Mr D Cullingford
Lead Member of the Examining Panel
M42 Junction 6 DCO Hearing
The Planning Inspectorate
Temple Quay House
2 The Square
Bristol BS1 6PN

28th October 2019

**Re. Representation submitted on behalf of David and Camilla Burton
Church Farm Accommodation, Church Lane, Bickenhill B92 0DN
Deadline 7 Submission**

Appendix 1 - St Peters and CDB Junction Reconfigured

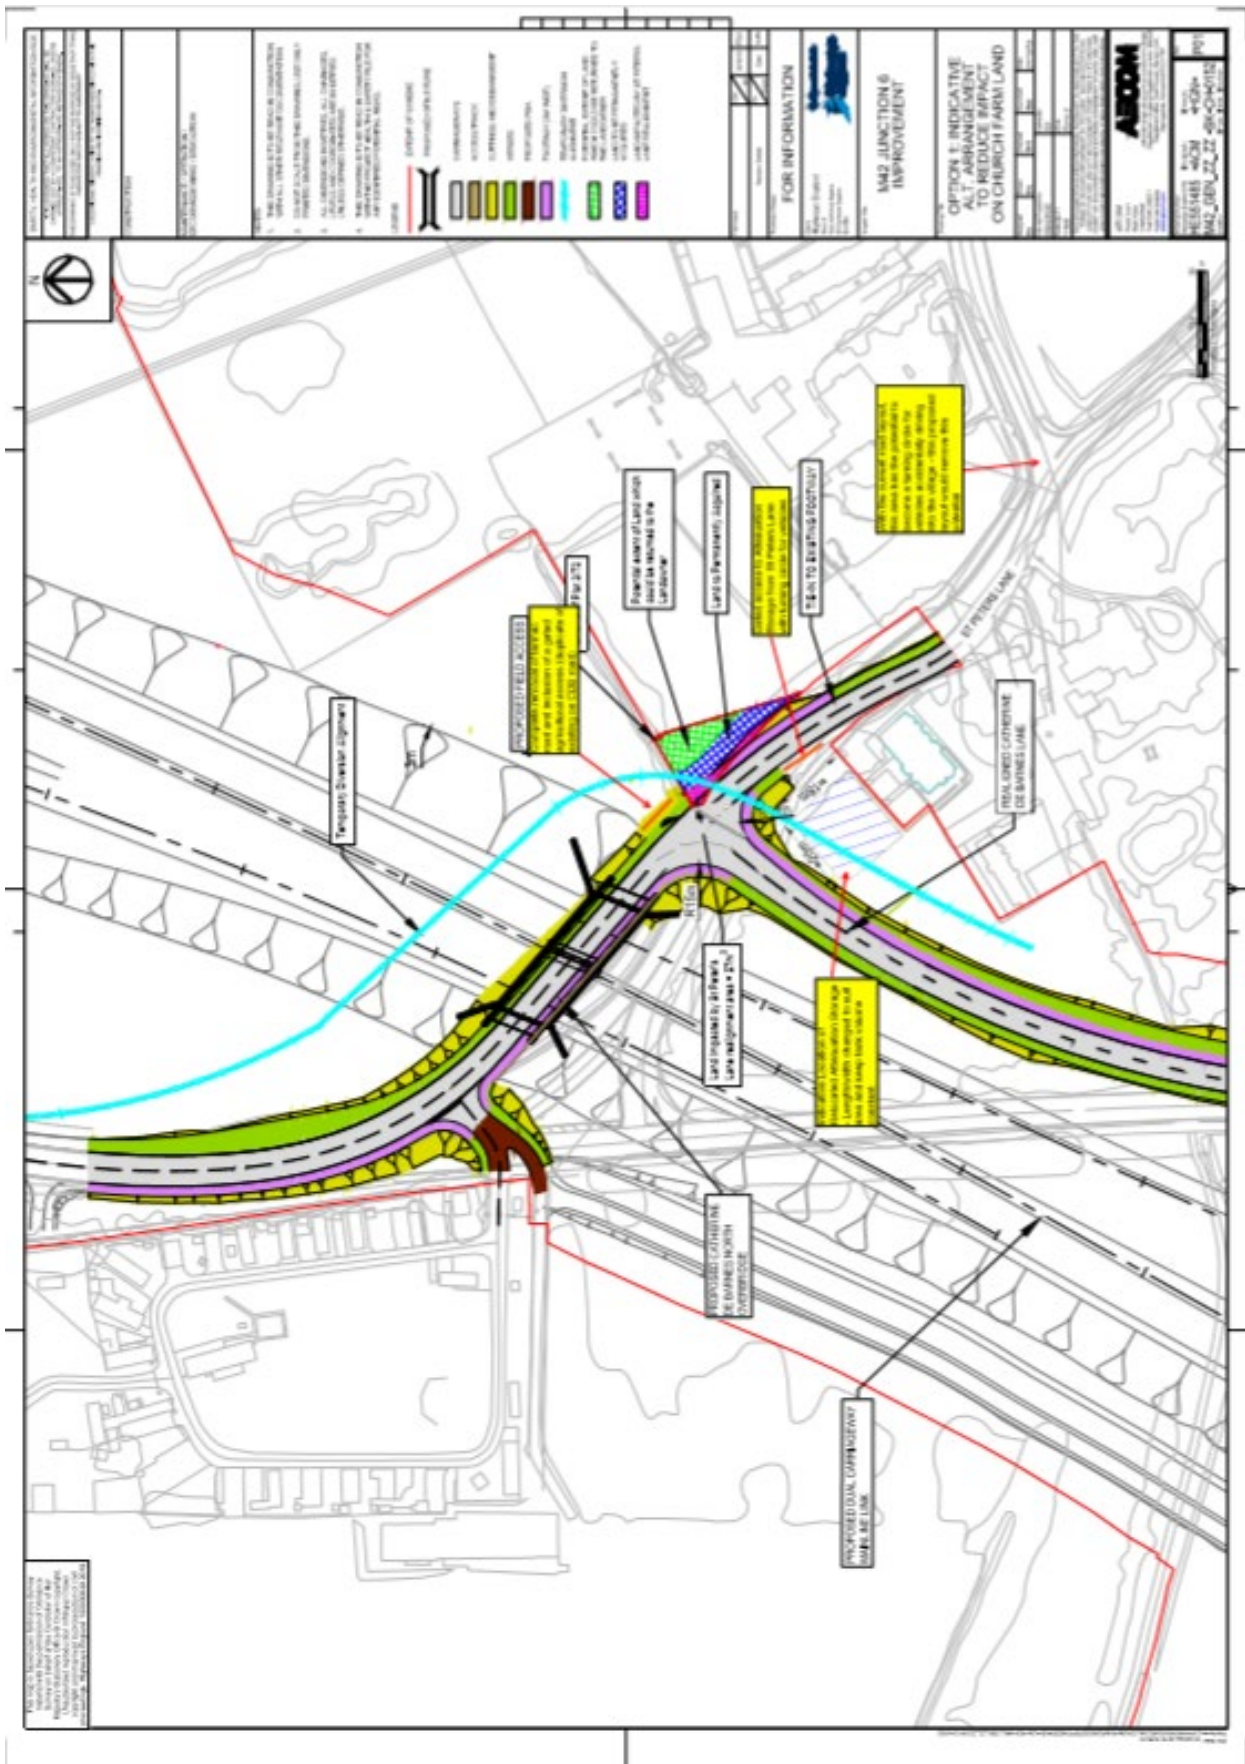
- a) We do not believe that the junction of St Peter's Lane and the Catherine-de-Barnes Lane is appropriately designed at present, particularly for the period during the construction of the new road, as all traffic using the re-aligned Catherine-de-Barnes Lane will effectively be directed in to the centre of Bickenhill Village unless the priorities are changed – thereby causing severe damage to the village environment, including old and historic buildings, roadside verges, highways and the resident's peaceable and quiet enjoyment of the village and its surroundings. Such change would occur despite the Conservation Area status of the village. We support the Inspector and Bickenhill Parish Council in requesting that the vehicular priorities are changed from those currently being shown at the junction, even if that ultimately requires a modification to the alignment of either road. Preventing

- traffic, including construction traffic potentially exiting the site compounds, from travelling directly in to the centre of Bickenhill Village is a key priority.

- c) We were **not satisfied** that Option 3 had been fully and properly assessed in the light of the 3 key principals which the Inspector outlined at the beginning of each day of the Hearing.

- d) We noted that the proposed attenuation tank has a surface area of 360 sq meters on HE's latest drawings, and from our own measurements it appears as though a tank of about that capacity together with an access point and short section of service track can be satisfactorily incorporated within Plot 3/68b on east side of realigned Catherine-de-Barnes Lane and to the South of St Peter's Lane.

- e) From our own measured survey of the area in question, we believe that there is sufficient room within that residual area to incorporate a tank measuring approx. 15m x 24m (or of similar dimensions), together with a max 4.5m wide access gateway off St Peter's Lane. Such gateway to lead to a Y-shaped parking and turning area within the compulsorily acquired land forming part of Plot 3/68b to enable easy vehicular access/egress to the attenuation tank.

- h) The potential for locating the attenuation tank to the south of St Peters Lane (Option 3) was previously dismissed because of the requirement for a service layby on the re-aligned Catherine-de-Barnes Lane. However we do not believe that such layby would be necessary given HE confirmation that the attenuation tank will probably only need to be accessed by the Drainage Authority once in every 6 months or so (subject to SMBC confirmation), as acknowledged at last week's Compulsory Acquisition Hearing. Therefore a straight agricultural field access (ie gate and hard-surfaced area) in to the land around the tank, to be taken directly off St Peter's Lane between the junction with the re-aligned Catherine-de-Barnes Lane and the edge of the village might well be the best possible solution.

- i) The available area for the attenuation tank in the residual part of 3/68b looks to be no smaller than the combined residual area within 3/73 a and b.

- j) We would respectfully request the Inspector to consider whether **modified Option 3 as above is a "more reasonable" solution** than HE's Option 1 or Option 4 for the tank, given the level of representation which has been made and the impact that either Option 1 or Option 4 will have on the neighbouring residential and commercial properties as a consequence of the adverse points relating to those Options which have been clearly set out to the Panel in previous evidence and correspondence.

Appendix 2 – Compound and Exits Reconfigured

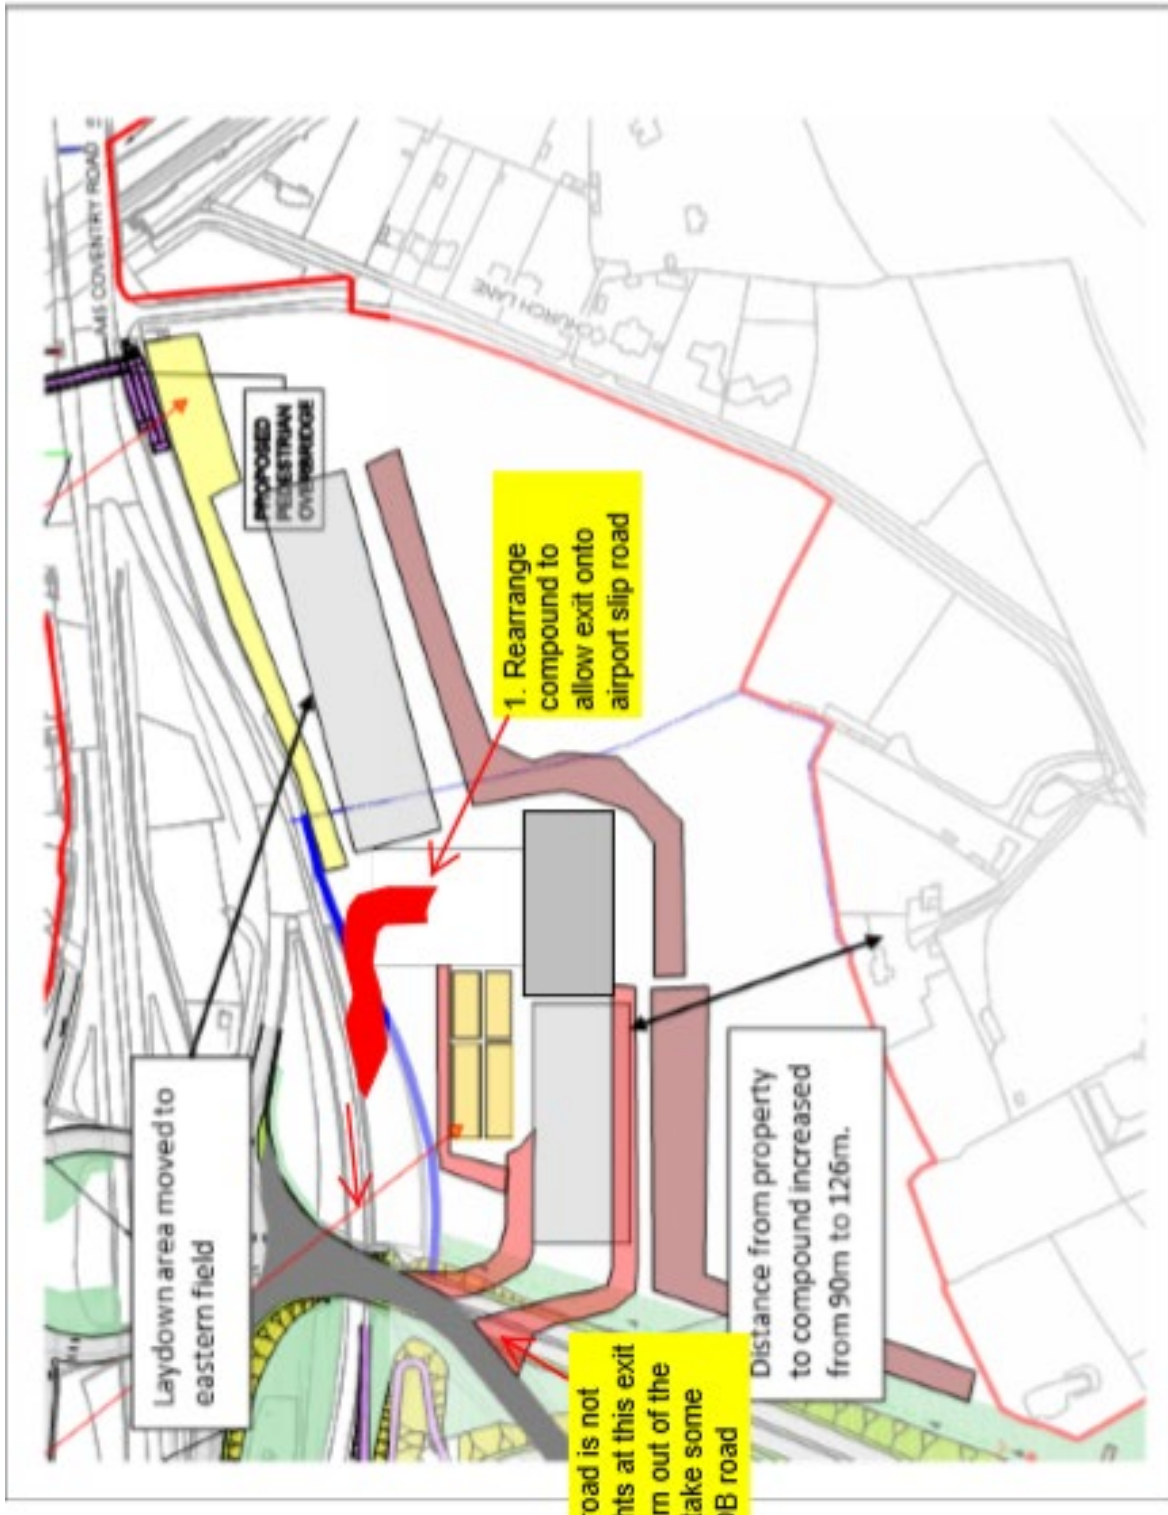
- a) We wish to draw the ExA's attention to the full implications for proposed left-turn only exit from the re-designed main compound on to the Catherine-de-Barnes Lane – as discussed in detail at last week's hearing - with all traffic now being directed south towards Bickenhill and Catherine-de-Barnes villages, rather than towards the nearby Trunk Roads and Motorway.

- b) We urge the panel to consider the possibility of providing a right turn from the exit lane out of the re-designed main compound (should the current layout be adopted) on to the existing Catherine-de-Barnes Lane, but under new Traffic Lights.

- c) The existing proposed road layout and junction priorities immediately to the west side of Bickenhill village (but on the east side of the new road) must be amended as otherwise traffic flow will continue directly in to St Peter's Lane and hence in to centre of village, which is a Conservation Area. Such disturbance to the residents and neighbourhood of the village should be deemed as being unacceptable in context of 3 key criteria outlined by the Inspector at the opening of each day of the

- Public Enquiry. We do not believe that such solution could be considered to be either a necessary or proportionate solution for DCO purposes.
- d) We have already submitted plans identifying an alternative solution for the exit from the re-designed compound area – directly on to the southern feeder road of the A45 towards Birmingham Airport, thereby passing under the Catherine-de-Barnes Lane.

2. If airport slip road is not viable, traffic lights at this exit to allow a RH turn out of the compound and take some traffic off the CDB road
